## DEVIATION REQUEST AND DECISION FORM

Project Name :	Waterbury
Schedule No.(s) :	4200000417
Legal Description :	TR IN NW4, SW4 SEC 28, E2SE4 SEC 29, NW4 SEC 33-12-64 DESC AS FOLS: COM AT NW COR OF SD SEC 28, TH S 00<30'55" E 1319.39 FT TO NW COR OF S2NW4, S 89<47'08" E 588.96 FT TO A PT ON ELY R/W OF EASTONVILLE RD FOR POB, CON S 89<47'08" E 1605.16 FT, S 00<12'59" W 435.00 FT, S 89<47'01" E 139.63 FT, S 00<12'59" W 330.00 FT, N 89<47'01" W 350.00 FT, N 00<12'59" E 30.00 FT, N 89<47'01" W 435.00 FT, S 00<12'59" W 377.02 FT, S 12<05'17" E 298.63 FT, S 25<18'38" E 227.74 FT, S 37<45'39" E 249.37 FT, S 51<48'59" E 239.45 FT, S 24<21'29" W 365.46 FT, TH ALG ARC OF CUR TO THE L HAVING A RAD OF 965.00 FT AN ARC DIST OF 18.61 FT A C/A OF 01<06'18" WHICH CHORD BEARS N 26<38'08" E, TH S 25<31'50" W 699.86 FT, N 28<50'14" W 419.93 FT, S 39<02'37" W 269.86 FT, S 28<43'09" E 182.42 FT, S 20<34'25" E 144.94 FT, S 04<10'28" W 63.70 FT, TH ALG ARC OF CUR TO THE R HAVING A RAD OF 1465.00 FT AN ARC DIST OF 64.34 FT A C/A OF 02<30'59" WHICH CHORD BEARS N 07<06'03" E, S 09<37'02" W 70.00 FT, S 12<40'04" W 679.15 FT, S 10<45'49" E 120.00 FT, TH ALG ARC OF CUR TO THE L HAVING A RAD OF 1280.00 FT AN A

Deviation Exhibit No 1  
**Saybrook Drive Deviation Request Location**

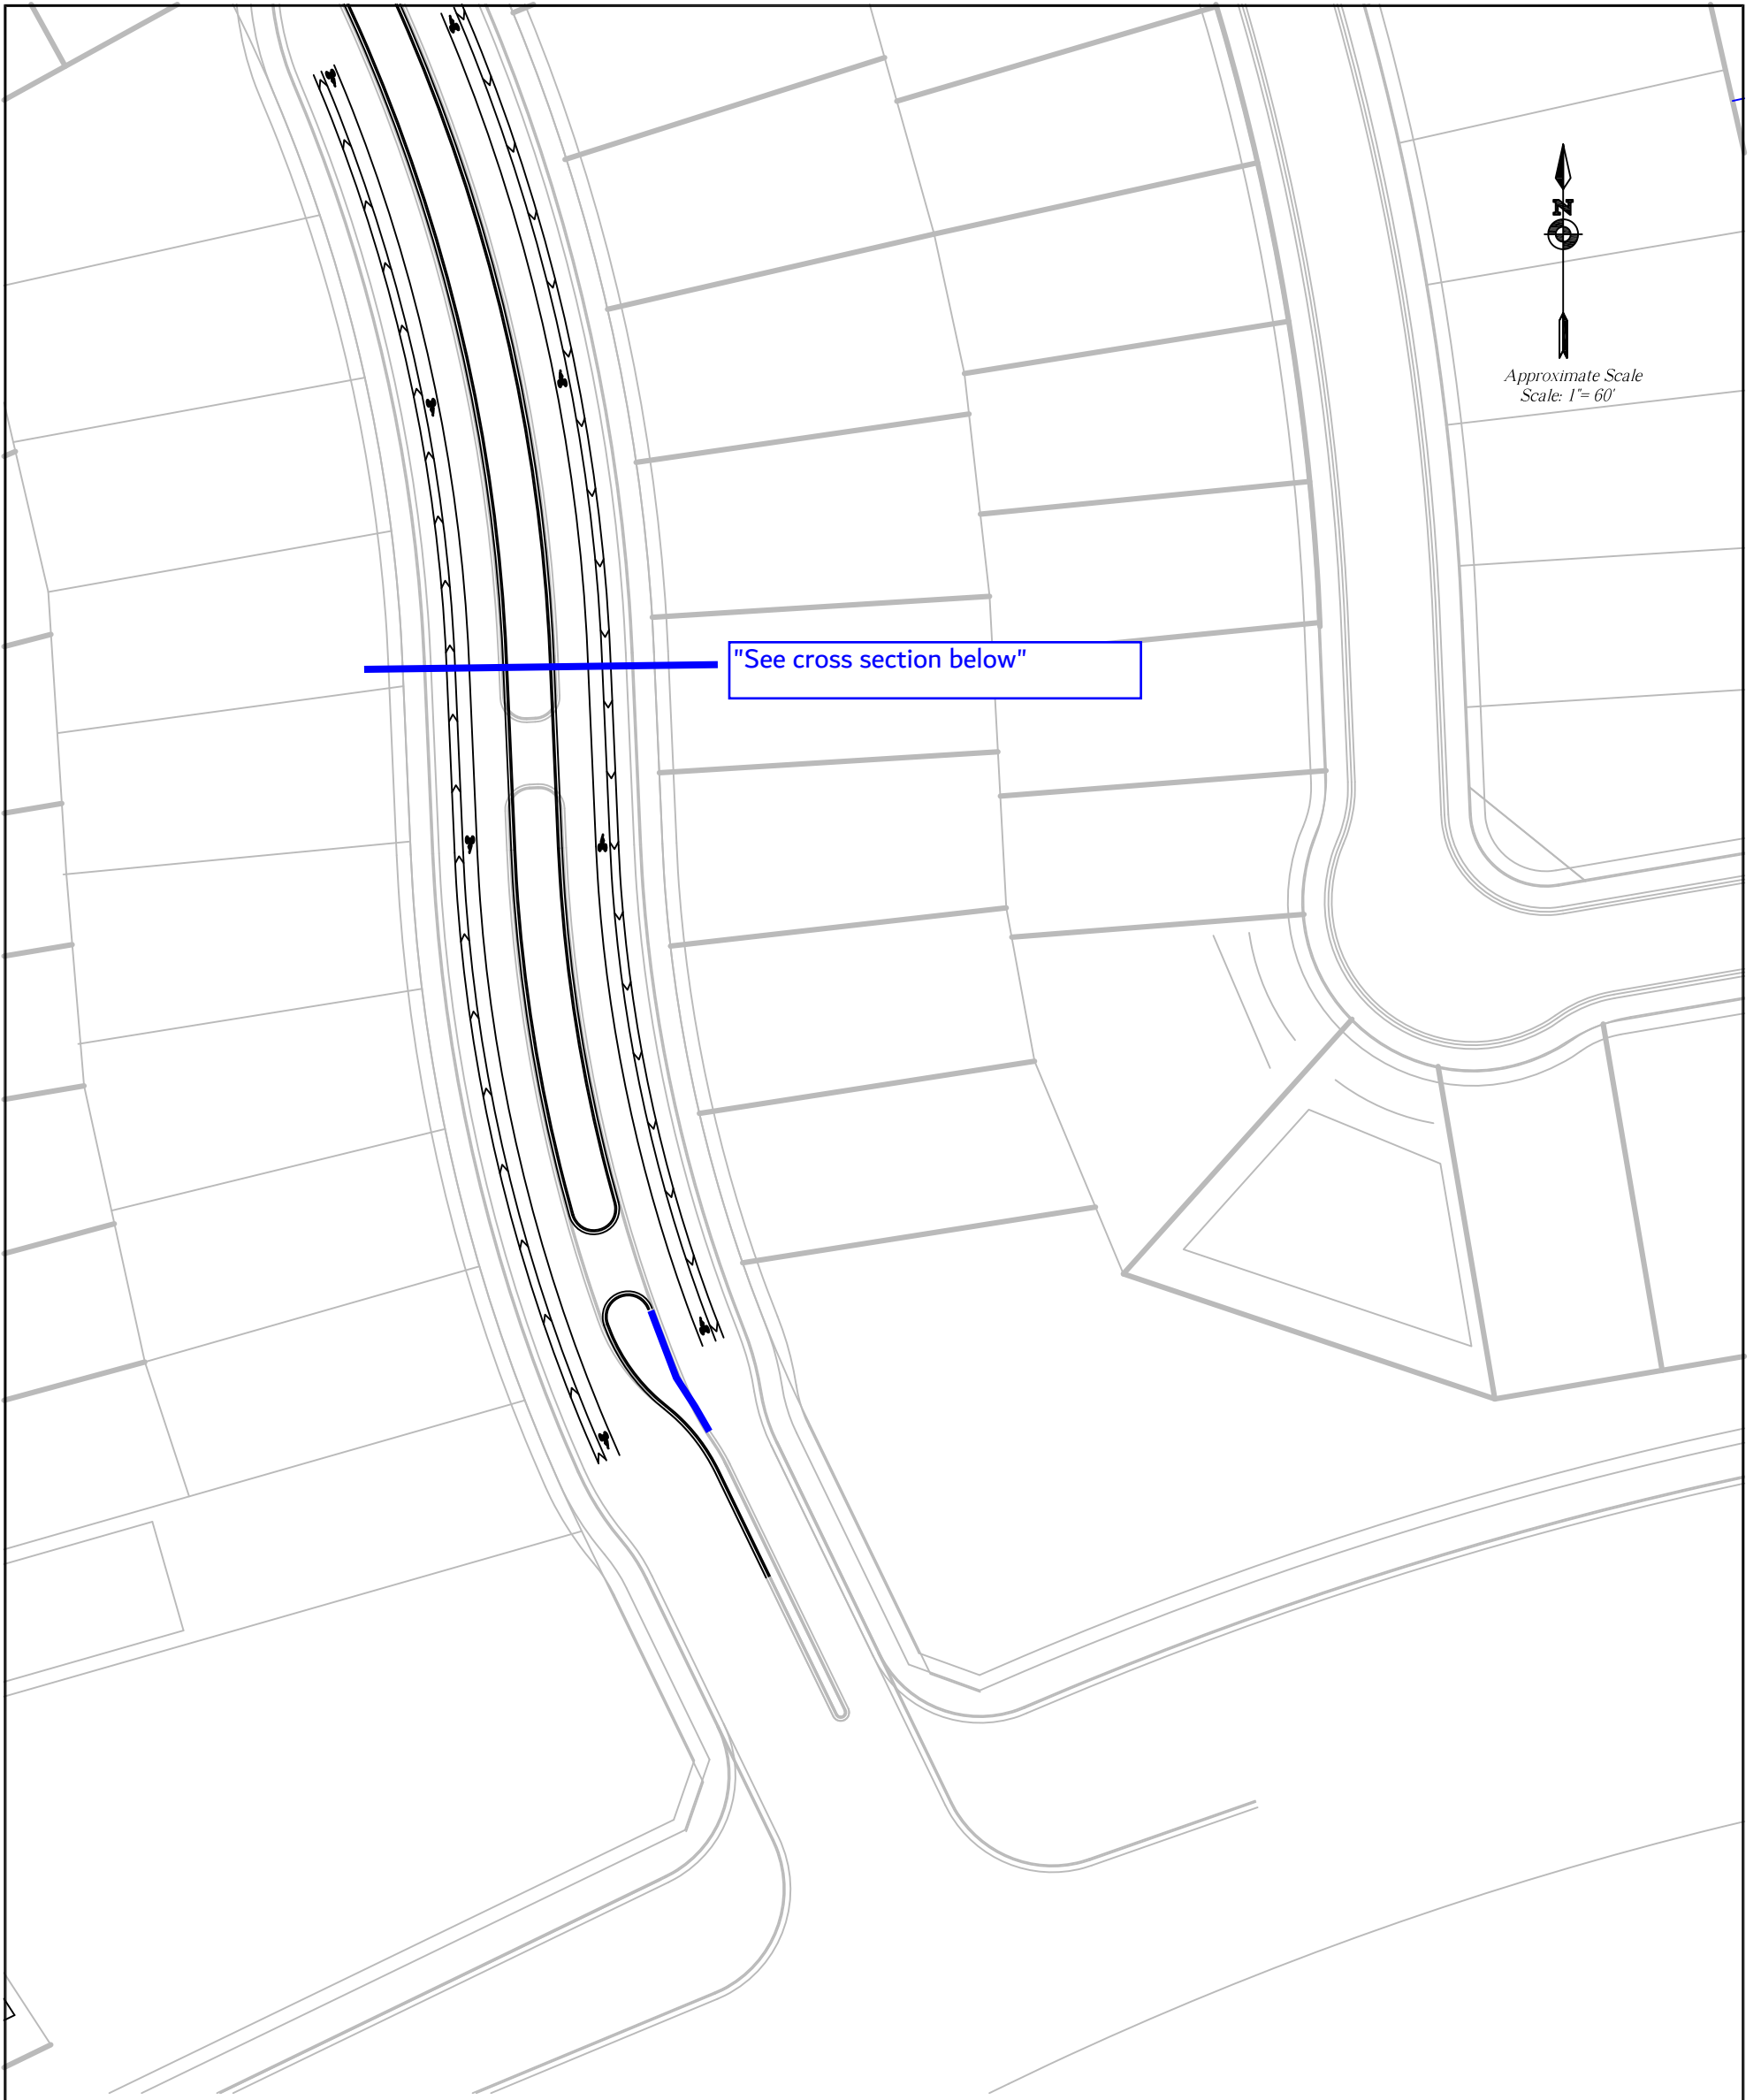
The deviation will allow for partial turn movement direct access for lots adjacent to Saybrook Drive (a planned Urban Collector) as no local or private roadways or alleys would provide access.

Direct access to Saybrook Drive is needed as there would be no other local or private streets or alleys adjacent to these lots.

Deviation Exhibit 2  
**Saybrook Drive**  
**Cross Section**  
 Waterbury (LSC #204220)

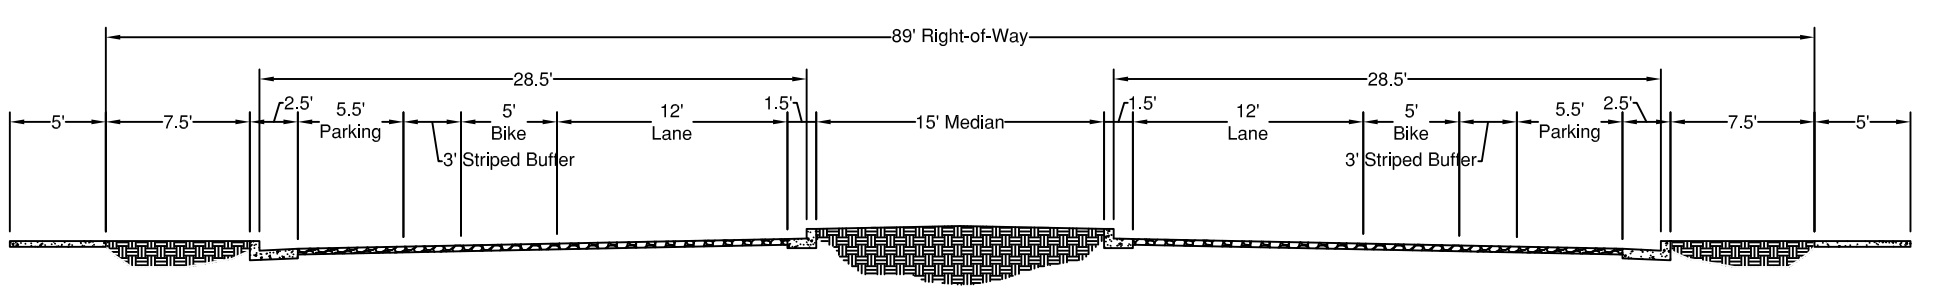
See the attached exhibit for the proposed modified cross section for Saybrook Drive.

The typical cross section for an Urban Residential Collector provides for a 36' of pavement (excluding gutter pan) in 60' of right-of-way with no median.

The proposed cross section would provide for 25.5' of pavement in each direction (7.5' for parking including gutter pan, a 3' striped "buffer", a 5' bike lane, a 12' travel lane (exclusive of 1' concrete gutter pan) and a 15' median in 89' of right-of-way.

The proposed cross section will provide for on street parallel parking which is not allowed on Urban Residential Collectors based on the criteria contained in Table 2-6. The adjacent parking lane and striped buffer would provide space for drivers to back out of driveways without having to back into the through traffic lanes. The intention is that parking would be restricted in front of the driveways (obviously) and "upstream" a short distance from each driveway to allow for backing maneuver into the combined buffer and parking lane width.

This request has been determined to have met the criteria for approval. A deviation from Section ^ of the ECM is hereby granted based on the justification provided.

<b>Approved</b> by Jeff Rice El Paso County Department of Public Works on behalf of Elizabeth Nijkamp, Deputy County Engineer	
04/27/2023 4:15:30 PM
